# Technical Service Information

## **CHRYSLER A904(30RH), A999(32RH), CHRYSLER A500(42RH), A500SE(42RE)**

### **VALVE BODY, FRONT PUMP, AND CASE CHANGES FOR 1995**

96-56

Figure 1

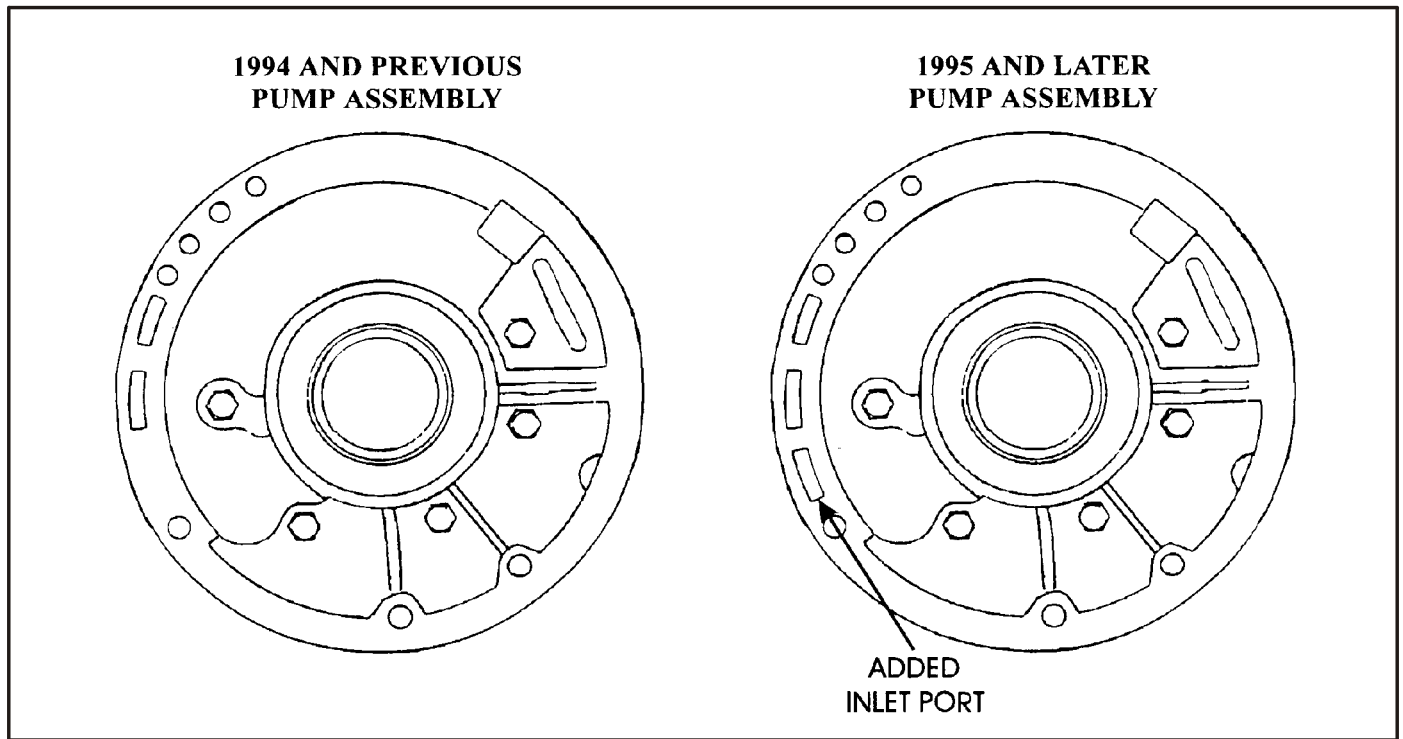
- (1) FRONT PUMP ASSEMBLY - Has an additional inlet port in the pump cover for the 95/96 model year, as shown in Figure 1, to accommodate the changes in the main case. The pump body also recieved casting changes to enlarge the pump suction flow area.

Figure 2

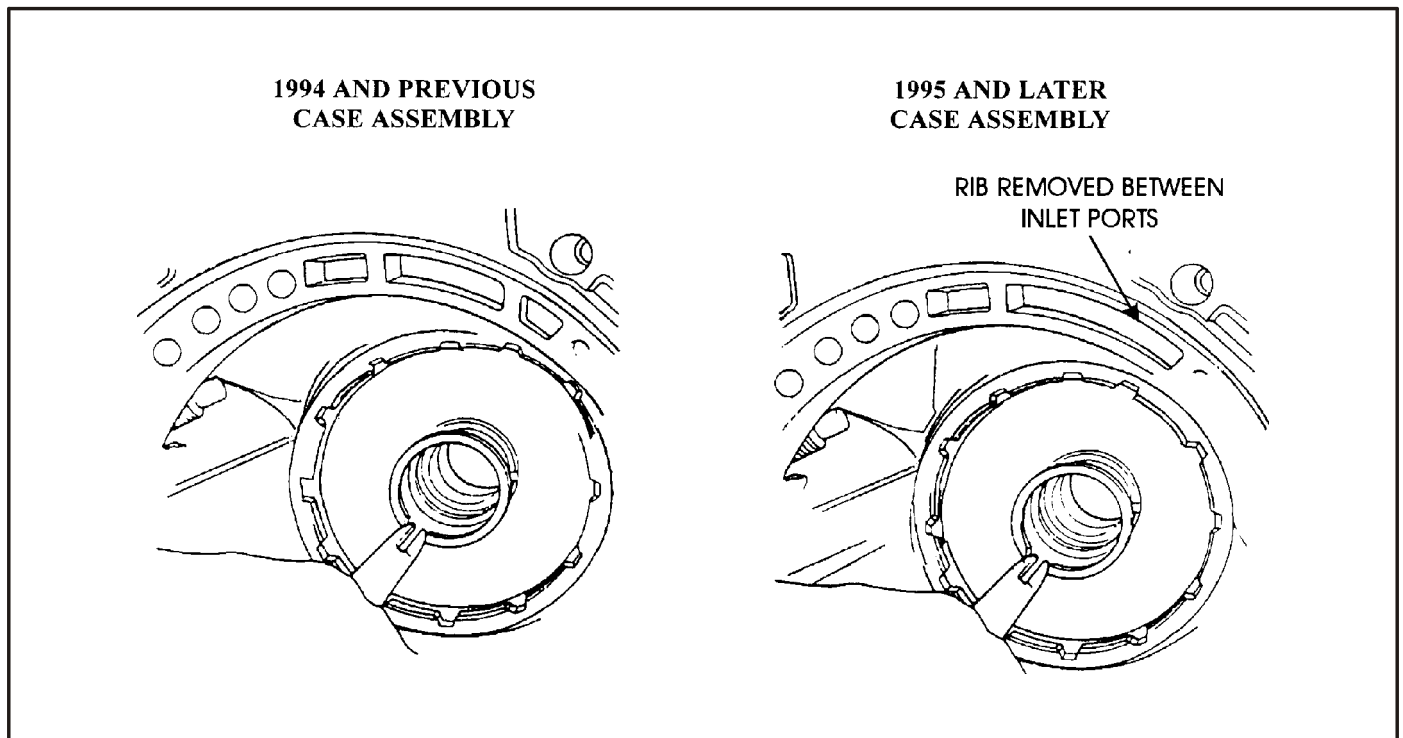
- (2) MAIN CASE - The rib in the case front pump face area, between the inlet ports was removed, as shown in Figure 2.  
The inlet port on the valve body side was also enlarged which required casting changes, and is shown in Figure 4.

Figure 3

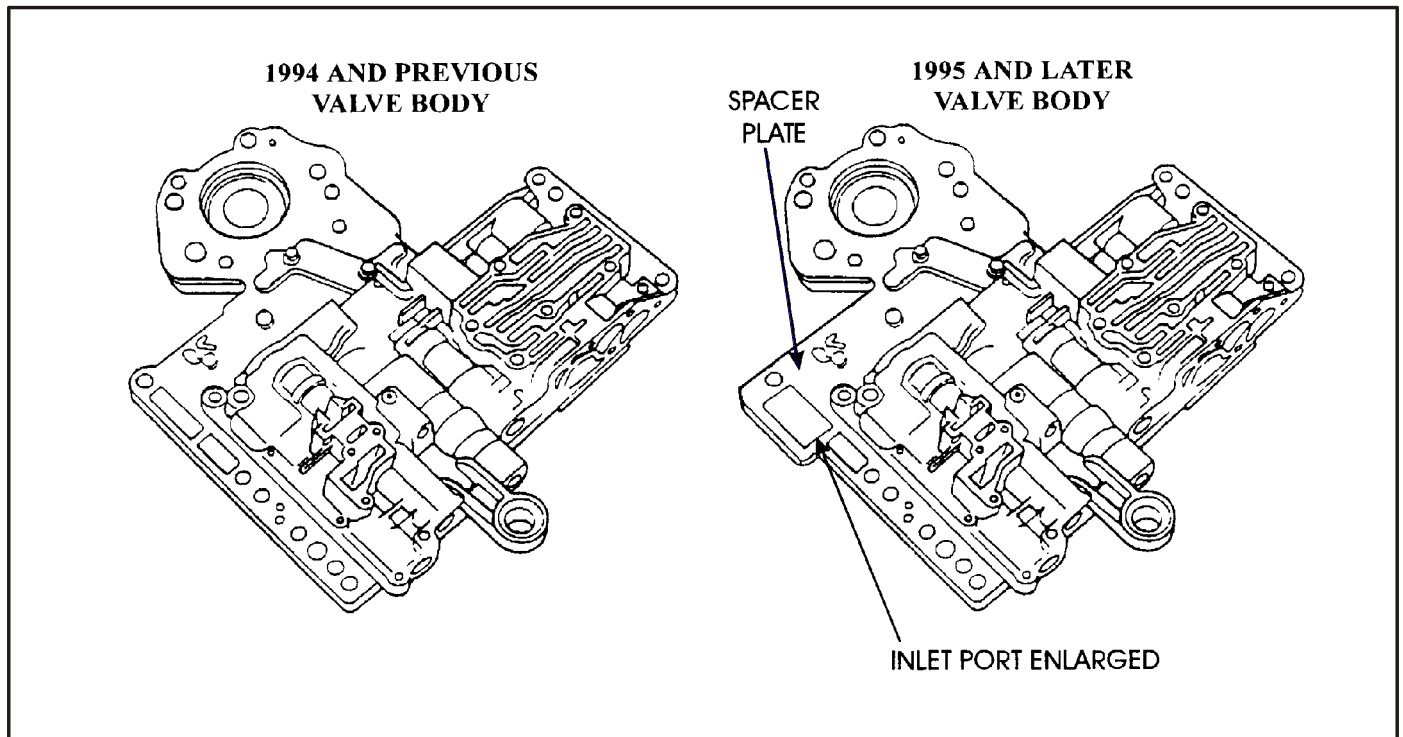
- (3) VALVE BODY - Casting changes were necessary to enlarge the valve body inlet port in the transfer plate, as shown in Figure 3, to accommodate the case changes.

- (4) SPACER PLATE - Inlet port made larger to accommodate the valve body transfer plate changes, as shown in Figure 3.
- (5) PUMP GASKET - Added hole in the pump gasket to accommodate the changes to the pump assembly and the main case, as shown in Figure 5.
